<b>Gachsaran Polymer Industries Company</b> <b>HDPE Plant</b>		
	<b>Filter Dryer Drawing for Refrigerator Package</b>	 	
PO No.: GPIC-PT-MA-PO-000-3029	Document Number: VD-GPIC-MA-3029-3029-0081	Rev. 00	Page 1 of 3

## Filter Dryer Drawing for Refrigerator Package

APPROVED BY	CHECKED BY	DRAWN BY	SCALE	QUANTITY	MATERIAL	TITLE
中村	中村	中村	-	-	-	LIQUID LINE FILTER DRIER 液管用 ドライヤ MDO 20W1~50W4 組立図 ASSEMBLY DRG.
MORIKAWA CO., LTD.						DRG.NO. F3-2805
						DATE 10-MAR-'20

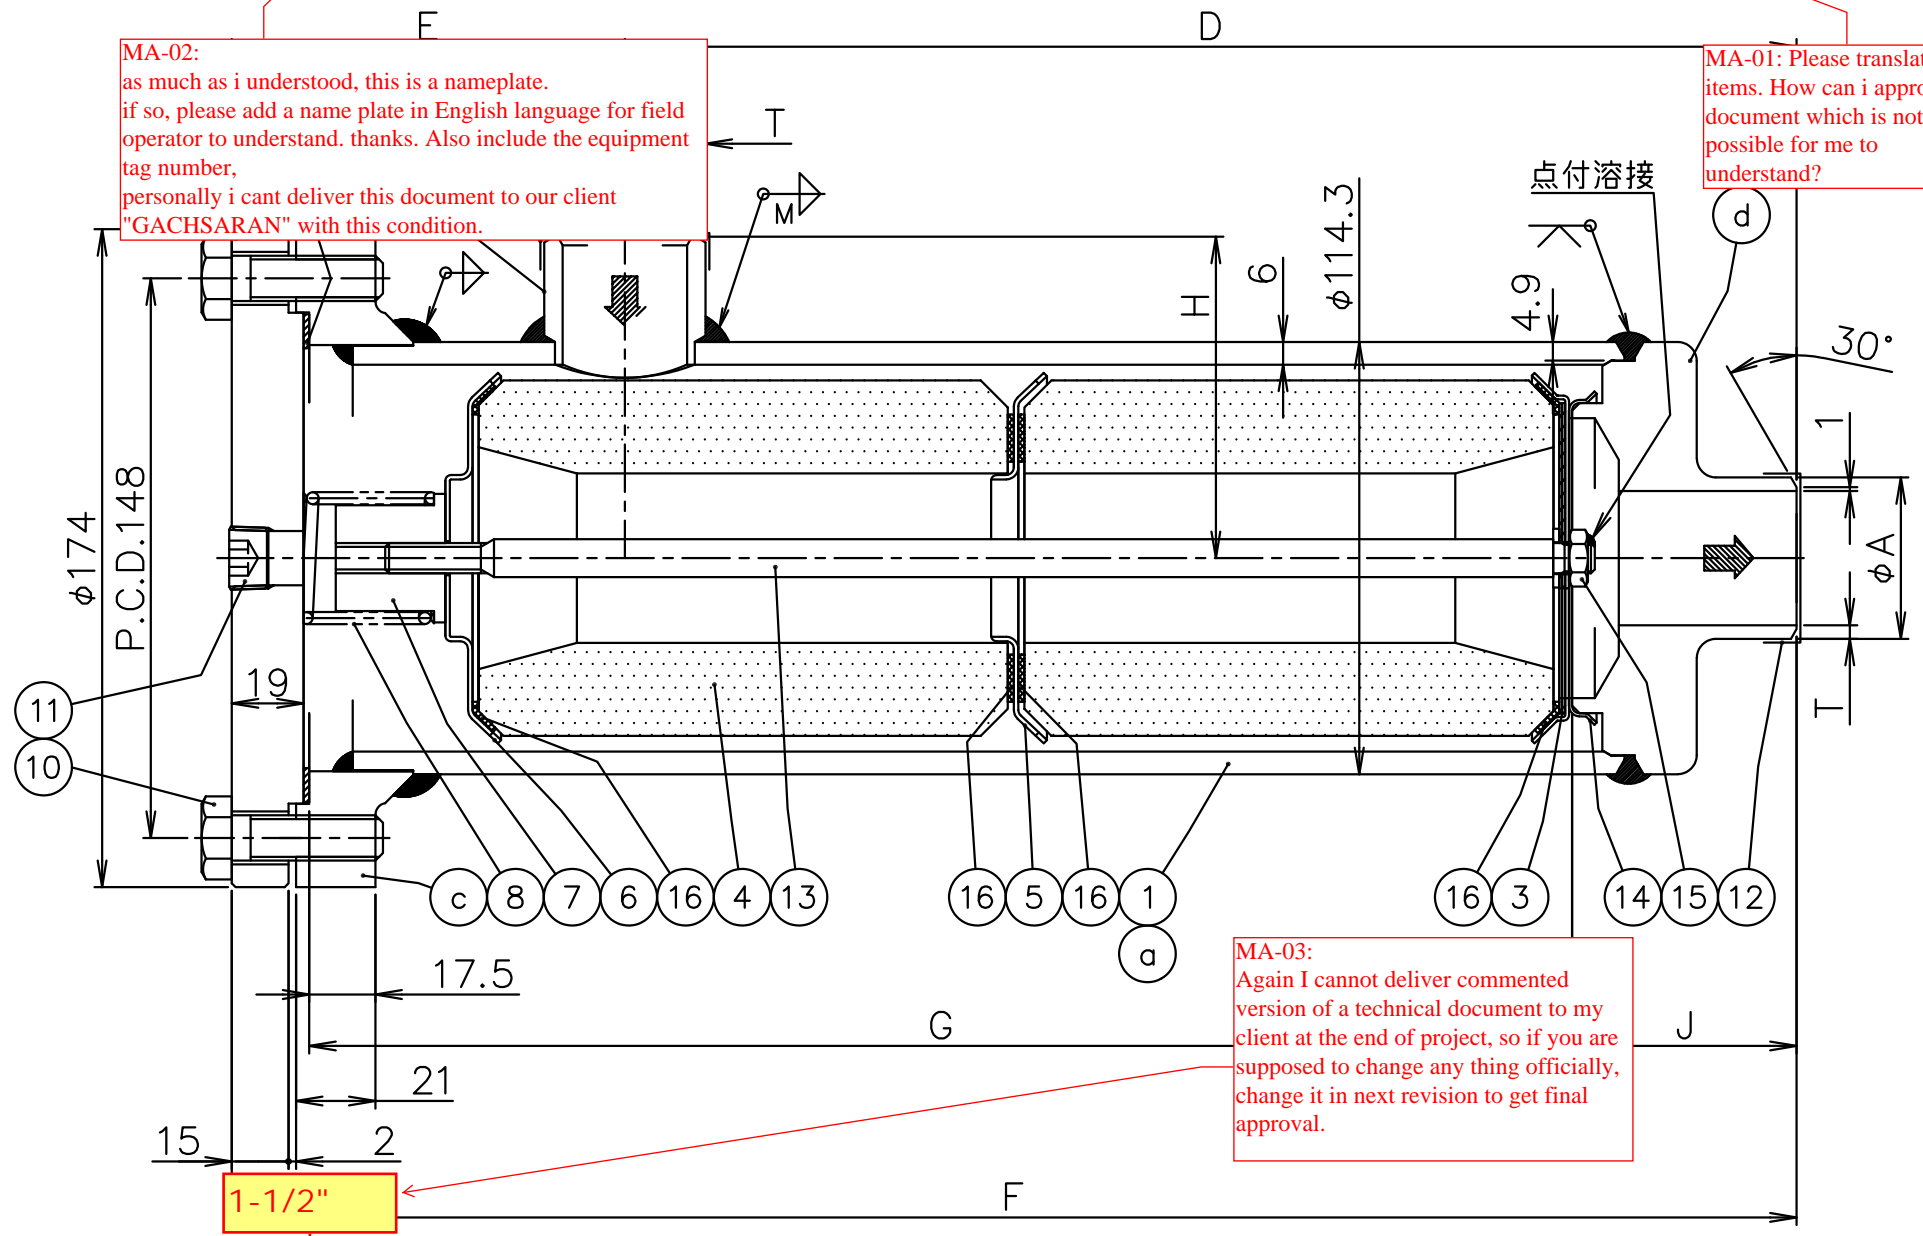
MA-02: as much as i understood, this is a nameplate. if so, please add a name plate in English language for field operator to understand. thanks. Also include the equipment tag number, personally i cant deliver this document to our client "GACHSARAN" with this condition.

MA-01: Please translate these items. How can i approve this document which is not possible for me to understand?

MA-03: Again I cannot deliver commented version of a technical document to my client at the end of project, so if you are supposed to change any thing officially, change it in next revision to get final approval.
